Project: IEEE P802.15 Working Group for Wireless Personal Area Networks (WPANs)

Submission Title: comment and resolution about CID 75,546 and 548

Abstract: comment and resolution about CID 75,546 and 548

Purpose: Contribution to IEEE 802.15.7 TG-VLC

Figure 41—CIE 1931 xy color coordinate

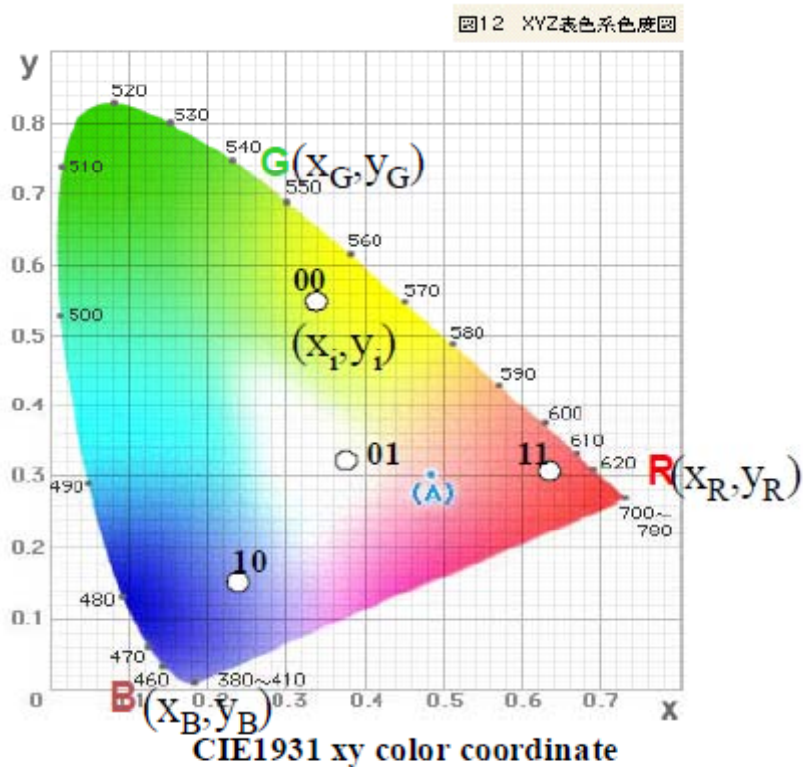
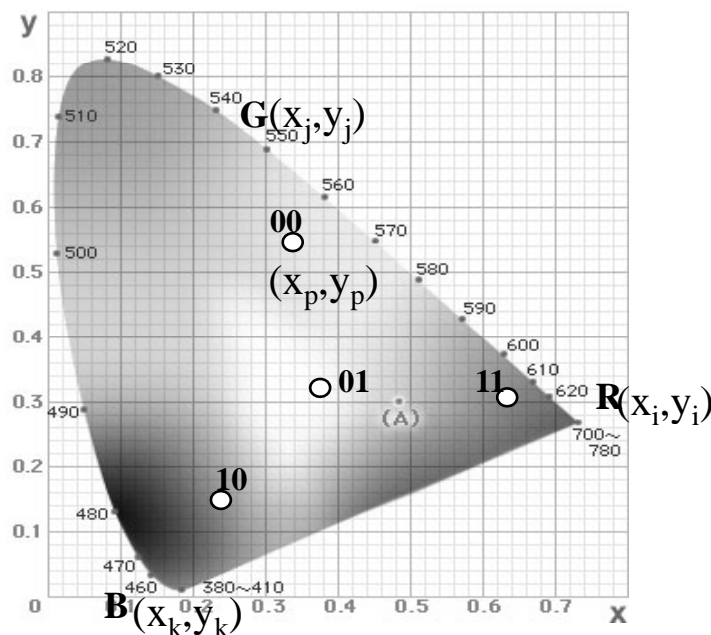
- figure 41 needs to be updated

- The figure 41 (page 56) should be replaced to the figure 34 in '15-10-0036-06-0007'.

- accept in principle – committee feels we actually do not need to include this chart; rather, reference the chart source and then give coordinates for the constellation points. Jason will provide coordinates ... TE remove this figure.

Figure 41 [reference number] shows the CIE1931 xy color coordinates with the color mapping for 4 point CSK (4CSK). In this case, 4 color points are defined. That means this system can send 2 bits data information per symbol.

- Replace figure 41 with new figure (B&W)
- Insert reference number after “Figure 41” at line 25 page 56
- Insert next reference in reference list in Annex B.
 - ◆ CIE (1932). *Commission internationale de l'Eclairage proceedings, 1931*. Cambridge University Press, Cambridge.
